# **TECHNICAL BULLETIN**

TB No.: **2AV-002**

**MODEL:** KM-1530, KM-2030

**SUBJECT:** Replacing the 'PULLEY, BYPASS'

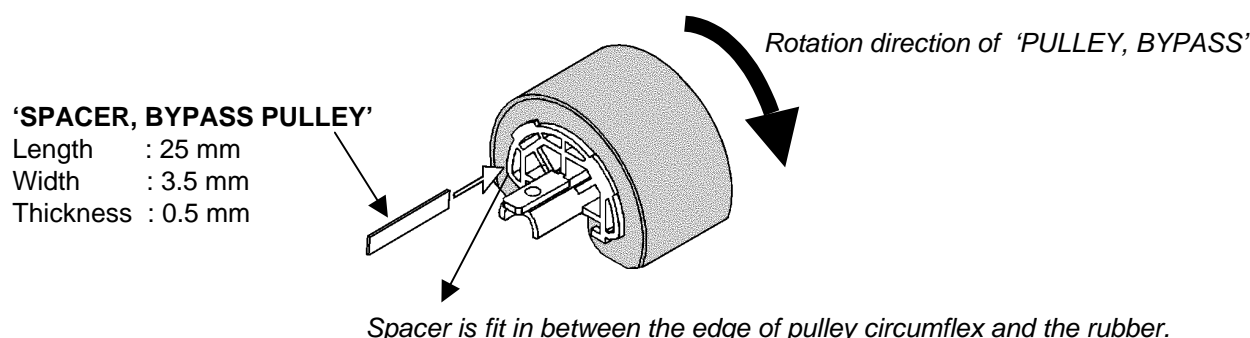
Please be informed that the 'SPACER, BYPASS PULLEY' has been added from mass-production and onwards.

The 'SPACER, BYPASS PULLEY' has been inserted between the resin and the rubber part of the 'PULLEY, BYPASS' as a countermeasure for the misfeed of envelopes from the bypass and to improve the paper feed conveyance of this semicircular pulley.

If replacing the 'PULLEY, BYPASS', please pull out the inserted spacer. After that reinsert the spacer in the new 'PULLEY, BYPASS' as indicated in the figure above.

When pulling the spacer out, the rubber of the pulley needs to be peeled off slightly. Please mind not to reuse an old pulley.
